A/E Firm: WRA Architects		PM Firm: CBRE Vanir JV	Date: 12-10-2025
Org #: 159	School Name: L.L. Hotchkiss Elementary School	Bid Pack #/ CSP#: 207325	Addendum #: 1

**DALLAS INDEPENDENT SCHOOL DISTRICT
PROCUREMENT SERVICES
ADDENDUM NO. 1
CSP 207325 – L.L. Hotchkiss Elementary School - Renovation**

The Purpose of this Addendum No. 1 is to provide an alternate bid and updated the drawings and specifications:

REVISIONS:	
No.	Date
ADDENDUM NO. 1	12/10/2025
JOB NO.	2239
DATE:	12/10/2025
DEMOLITION PLAN	
C1.01	
© WRA Architects, Inc. 2024

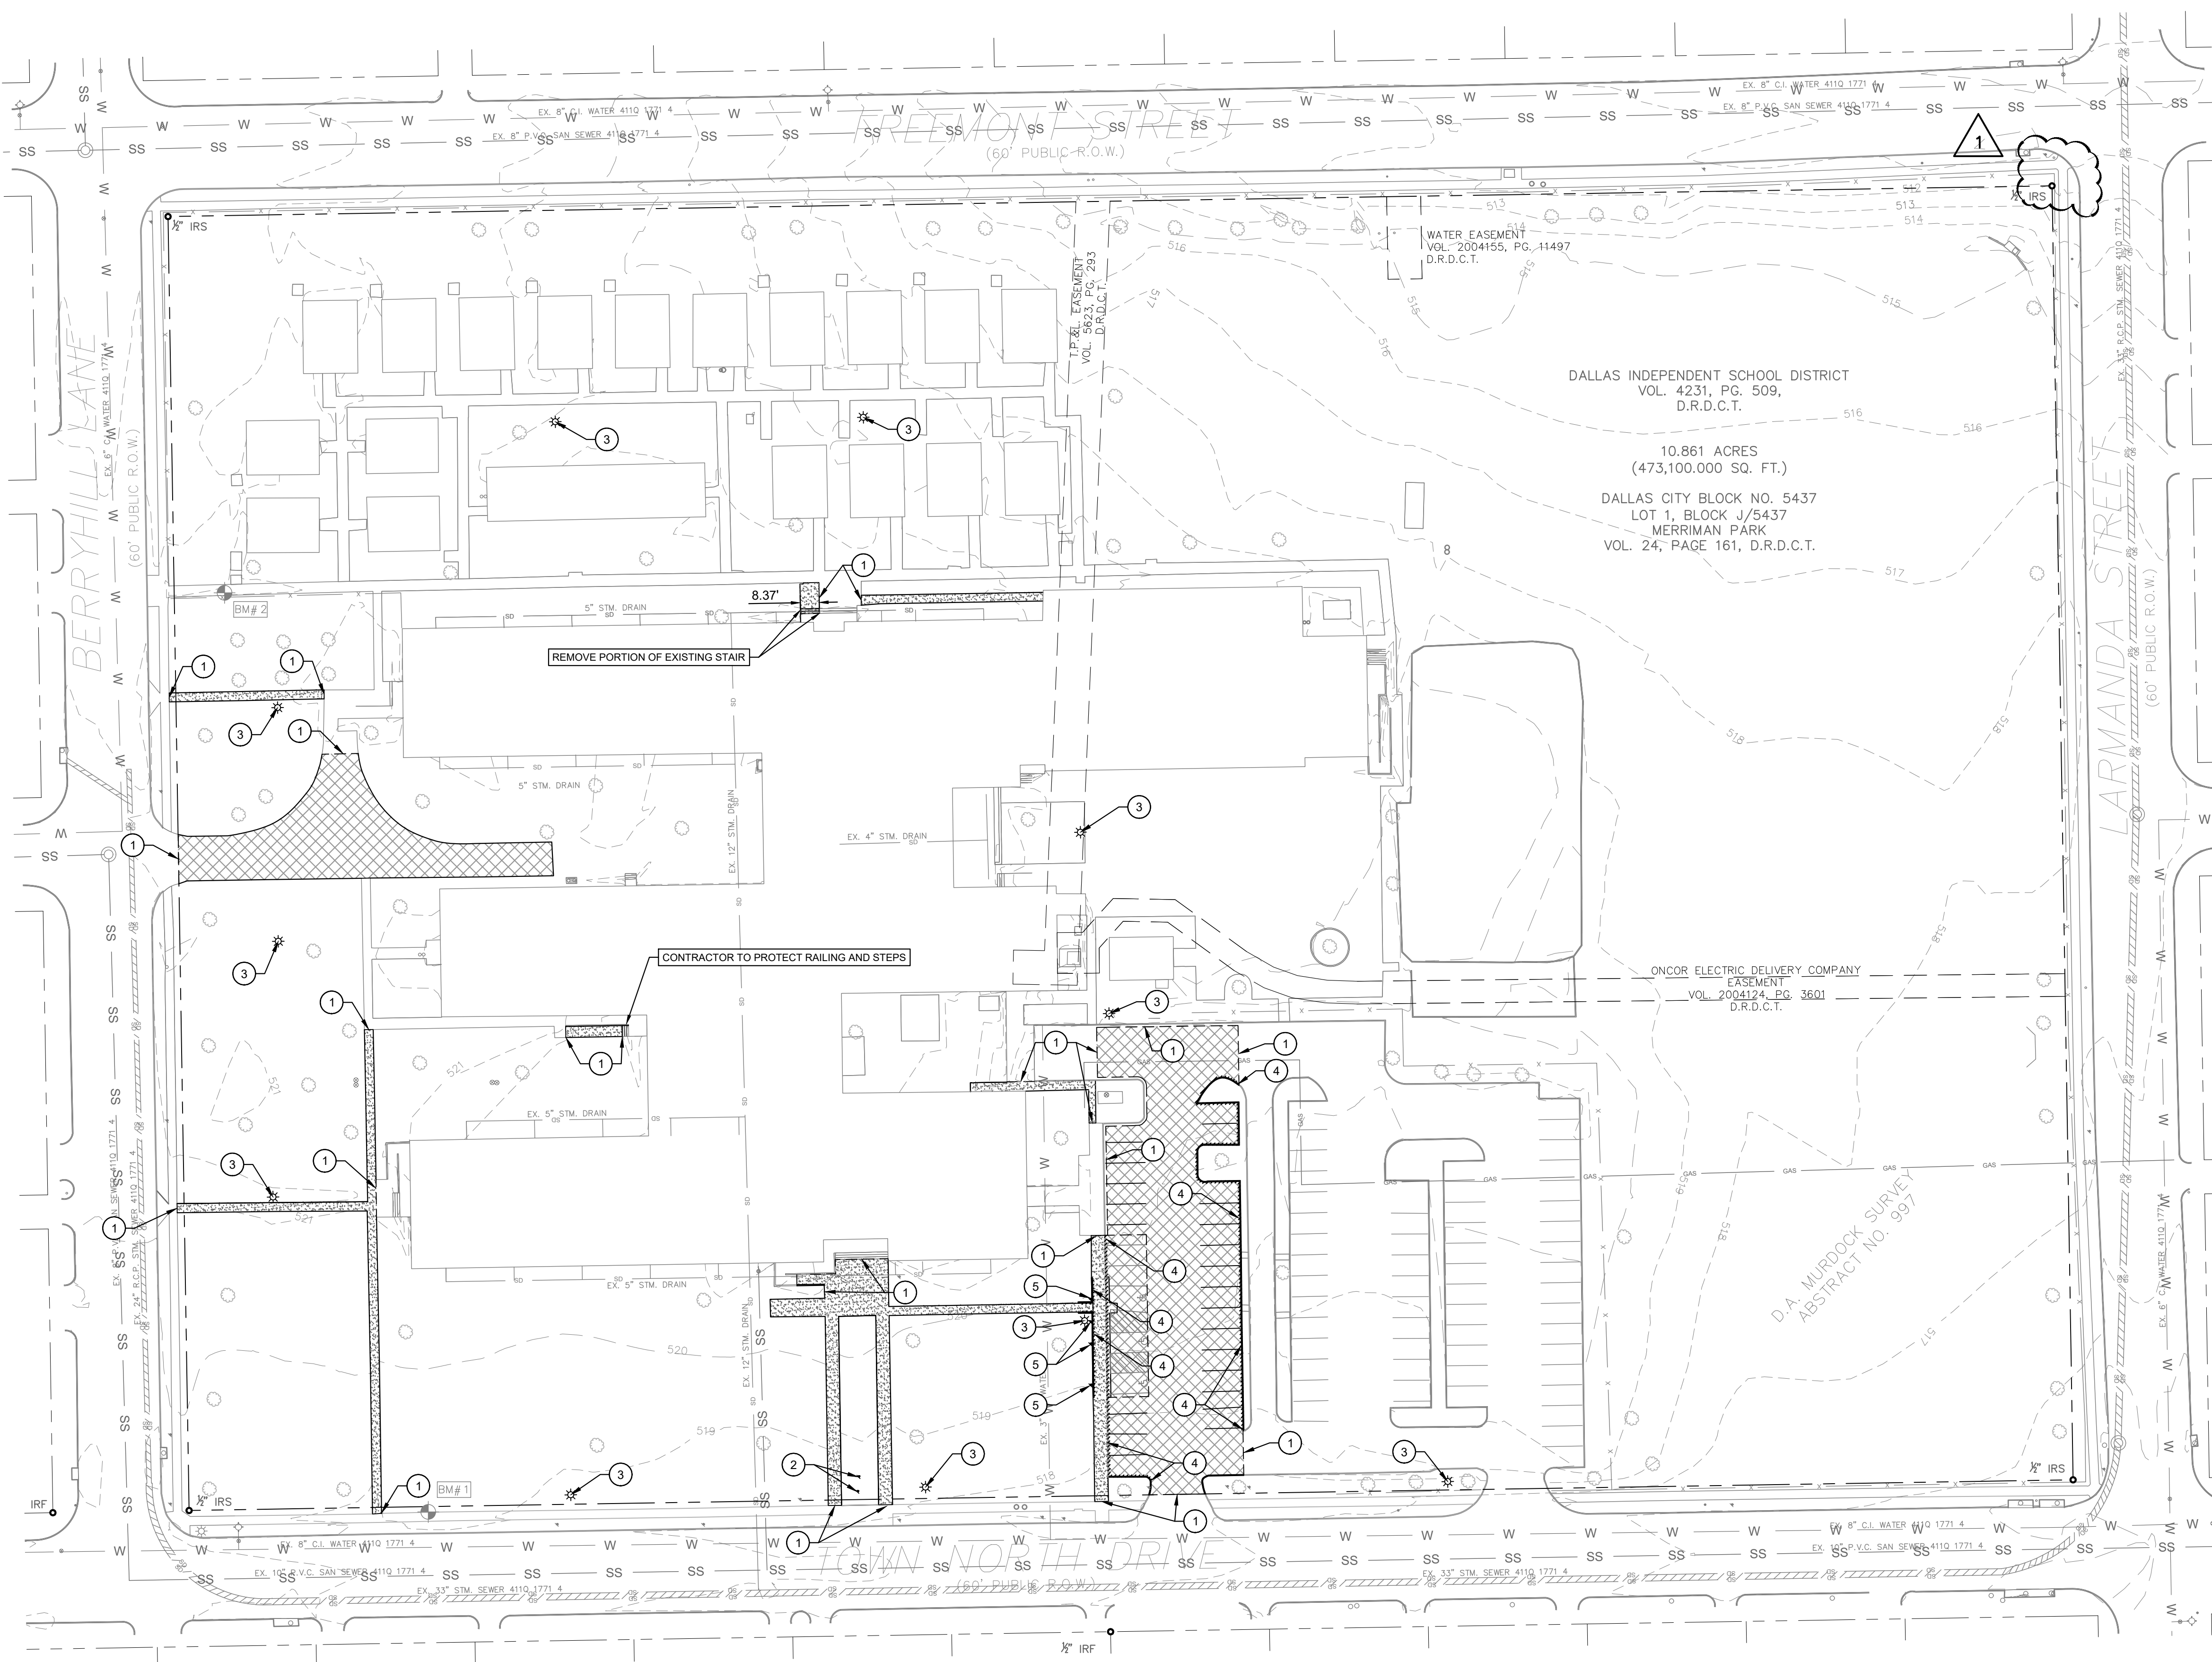
- A. CLARIFIED** no ROW pavement replacement will be required

DEMOLITION PLAN
- BID ALTERNATE

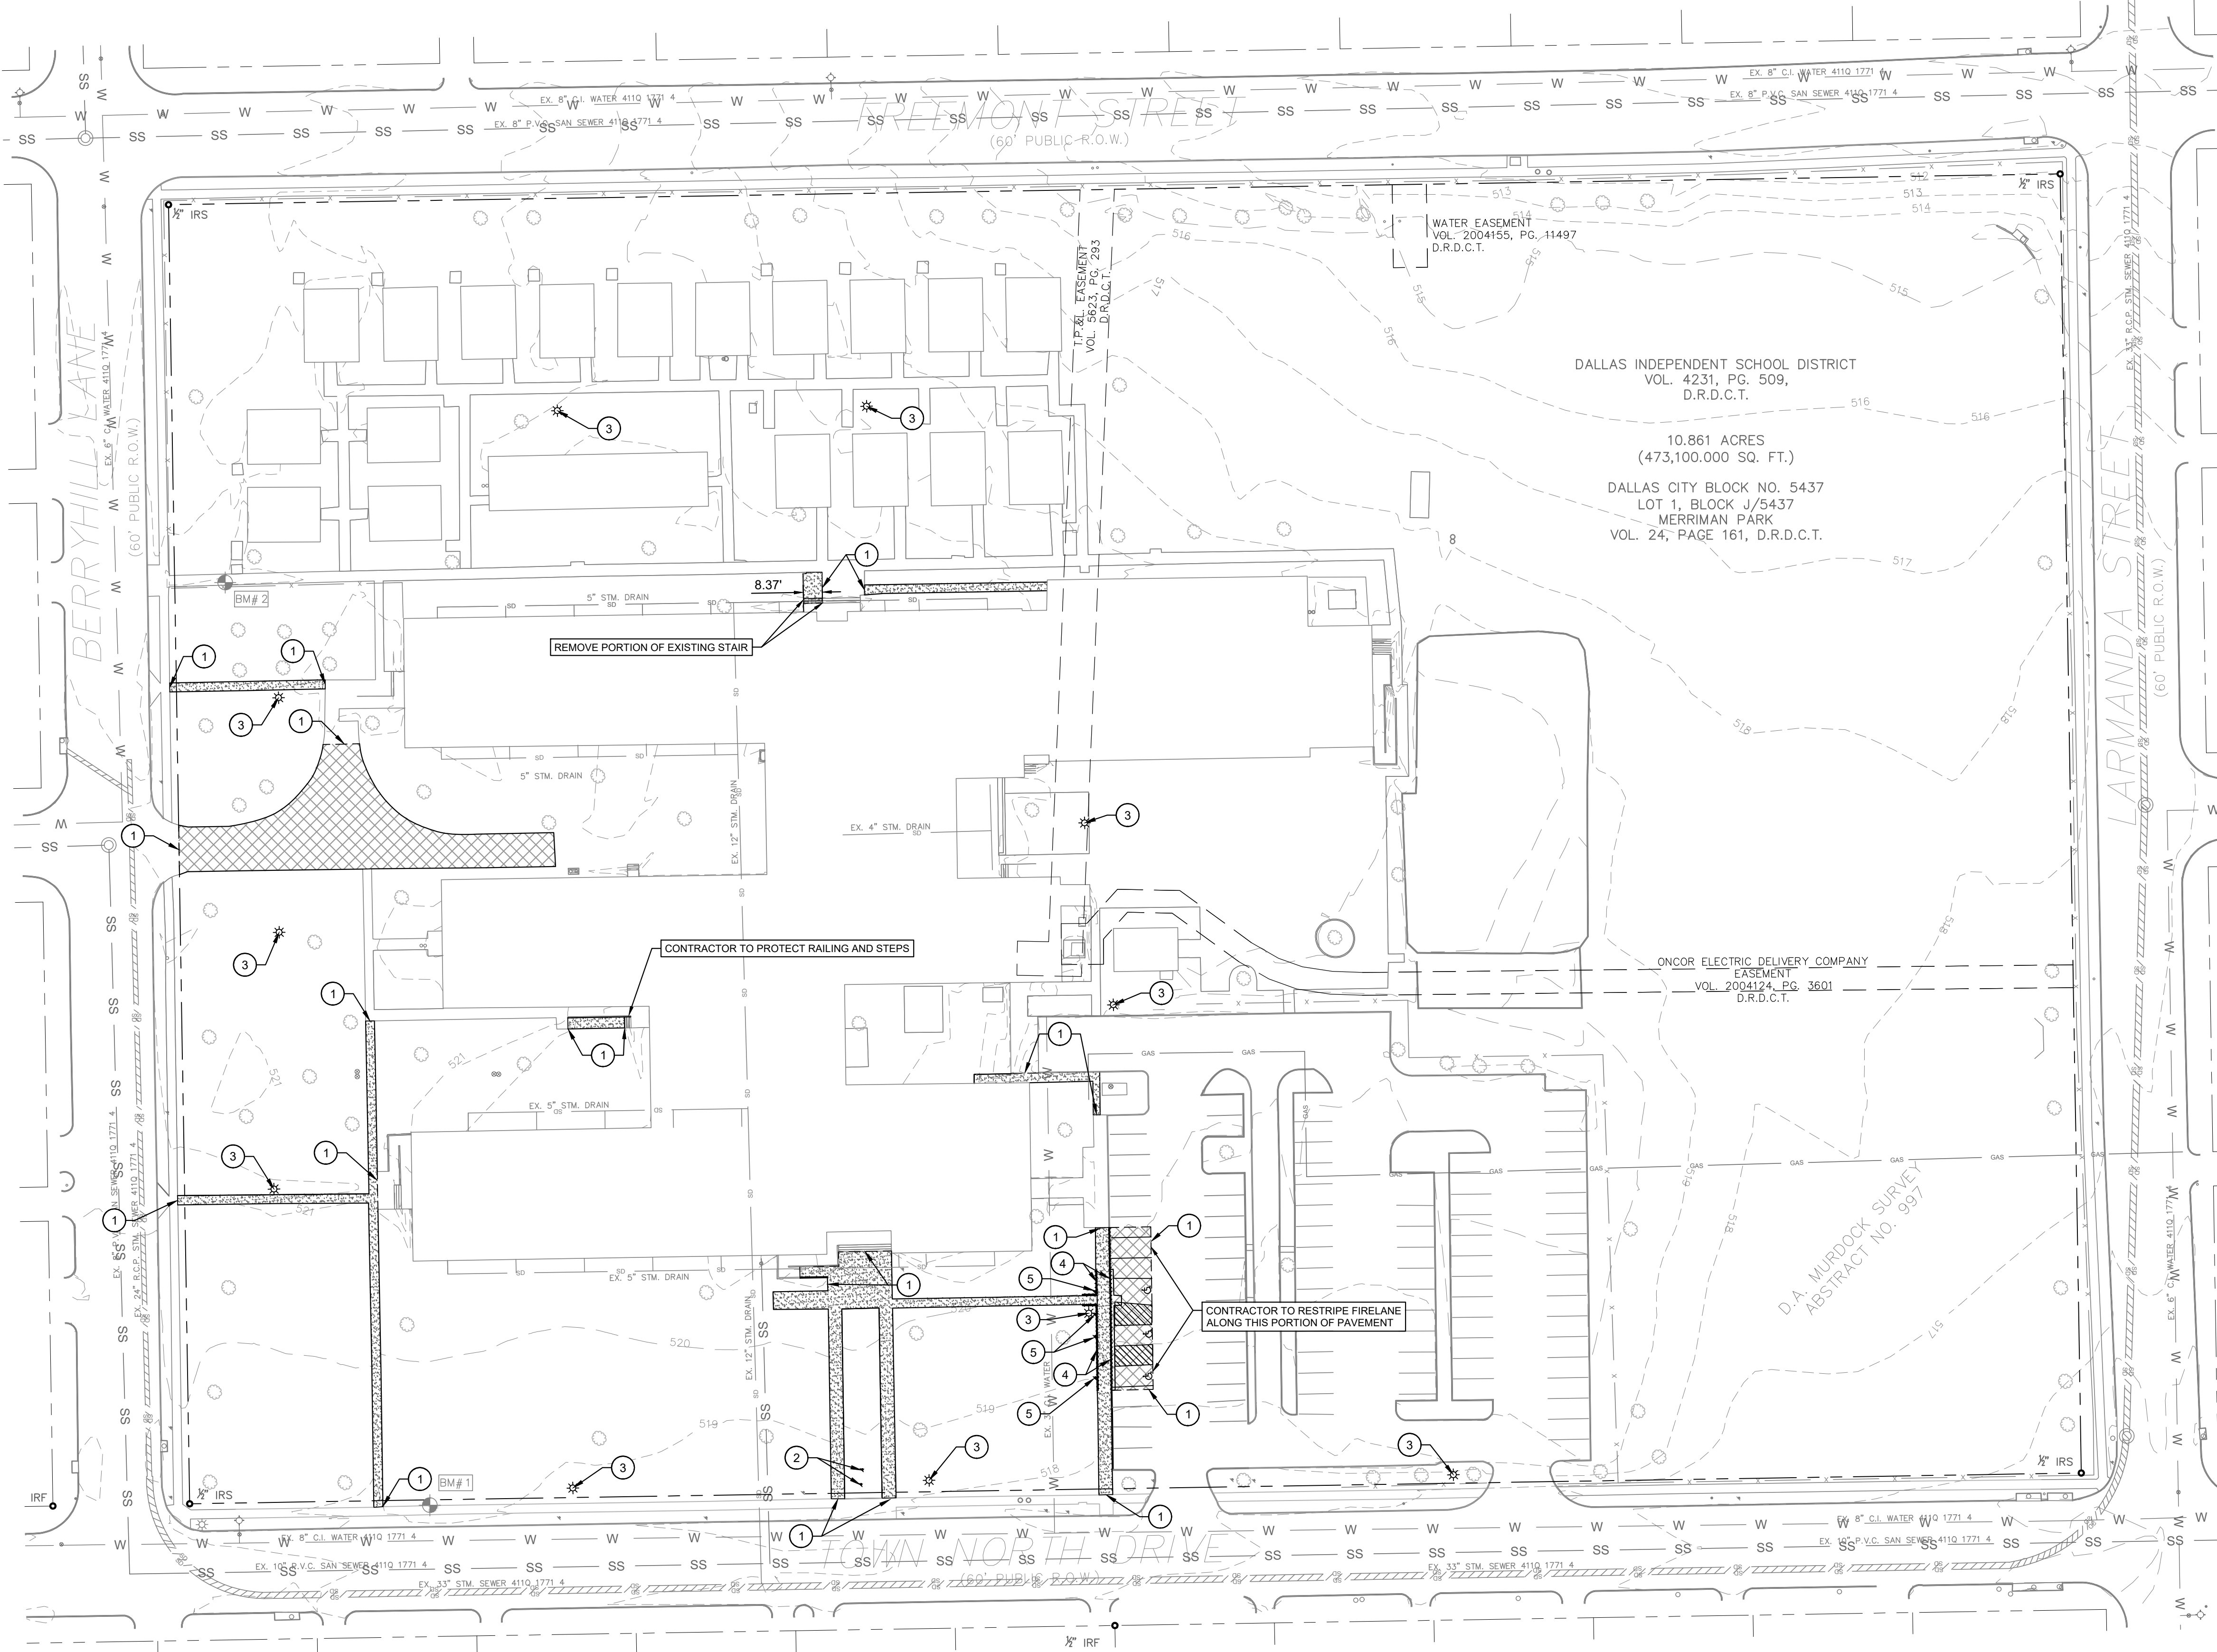
- A. REVISED** the south parking design to only demo sidewalk and the proposed ADA Stall locations
